# Product Change Notification (PCN)

PCN Number	508316	Date Issued	April 09, 2020
Reason for Change	Capacity change or tool replacement		
Change Type Description	This letter is to inform you that another set of tooling is being added to meet the current and future demands of this product. There will be no changes in the fit, form or function from the additional tooling when compared to the current tooling.		
Reason for Short Notice	New Capacity		
Assessment of Change	Product will be fully qualified before it is shipped. Qualification reports will be available after below listed date		
Internal Molex Qualification Date	April 20, 2020		
Sample Availability Date (Changed Part)	April 20, 2020		
Planned Implementation Date	May 09, 2020		
Method of Identifying Change	Cavity identification

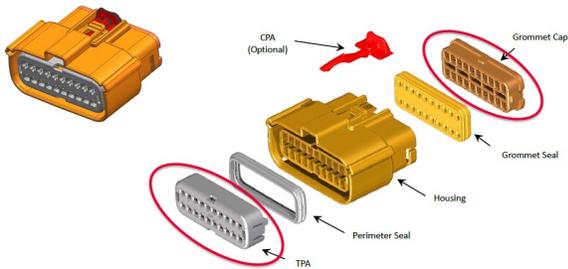
- MX150 2x10 RCPT TPA & CAP capacity mold is being fabricated in Molex Chengdu to support increasing demand
- Product Impact: No impact to fit, form, function
- Part Number Impact: see attached part number list
- Qualification Reports and samples available upon request after the date shown based on change management worksheet
